Technical Service Information

THM 200-4R NEW FILTER

New transmission fluid filter and seal.

Figure 1

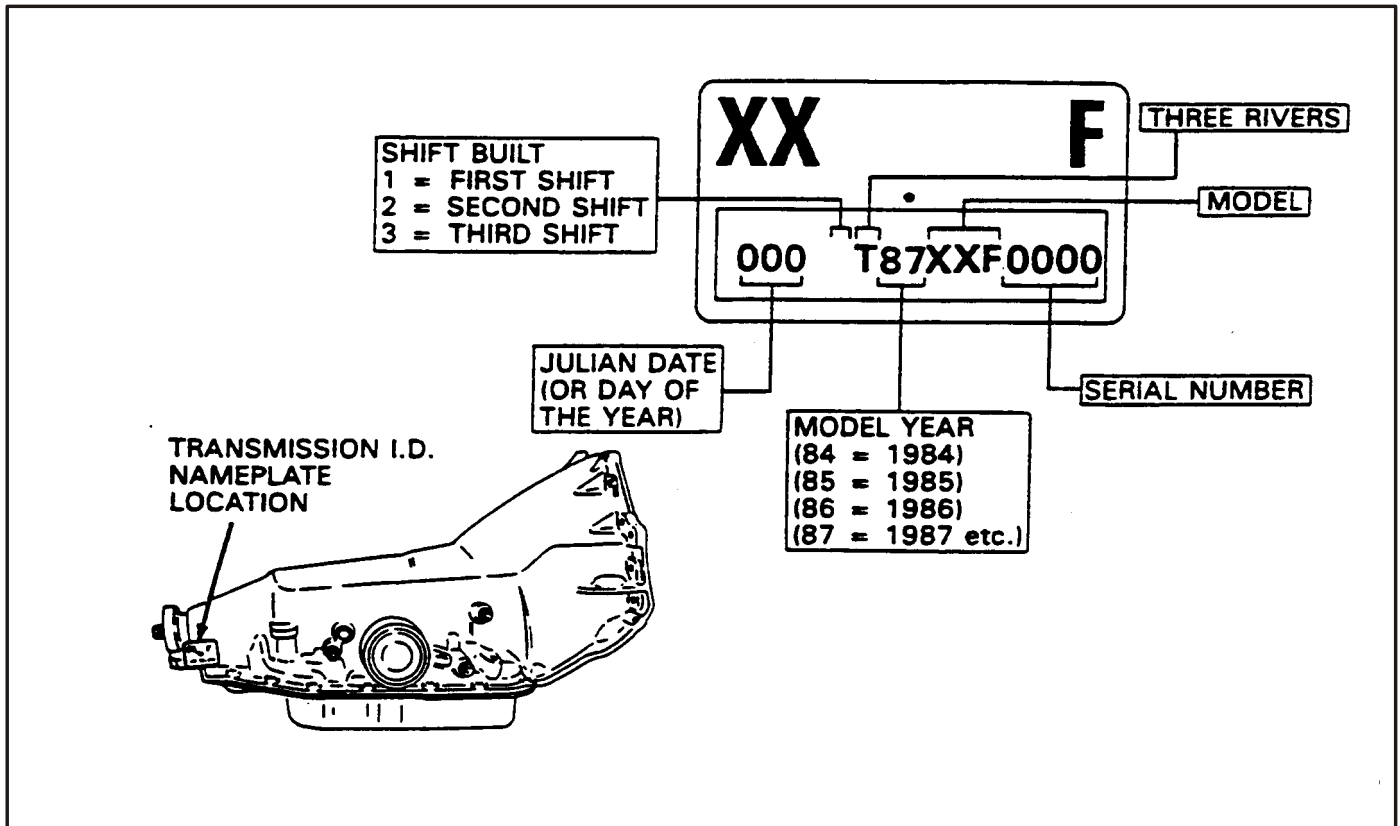
Date of Production Change: (Figures 1,2, and 3)

June 15, 1987, (Julian Date 166) new filter and previous seal in production for some 200-4R units.

August 28, 1987, (Julian Date 240) new filter and new seal in production for all 200-4R units.

Figure 2

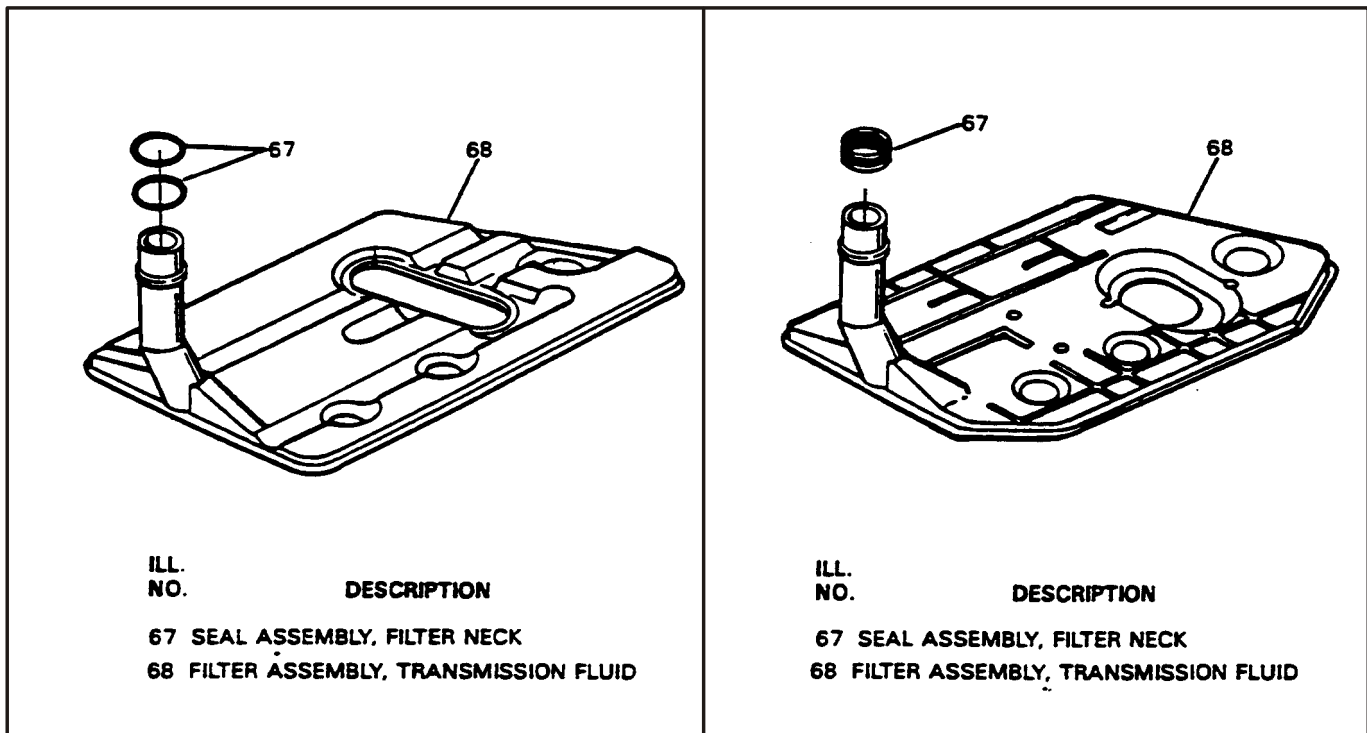
Refer to Figure 2 to identify previous design filter and seal. Refer to Figure 3 to identify new design filter and seal.

The new design filter and seal are released to service all 1988 THM 200-4R transmissions:
package number 8639958 (includes filter, seal and pan gasket).

When stock of the previous design filter and seal is depleted, the new design filter and seal will be made available to service 1987 and all prior year 200-4R models.
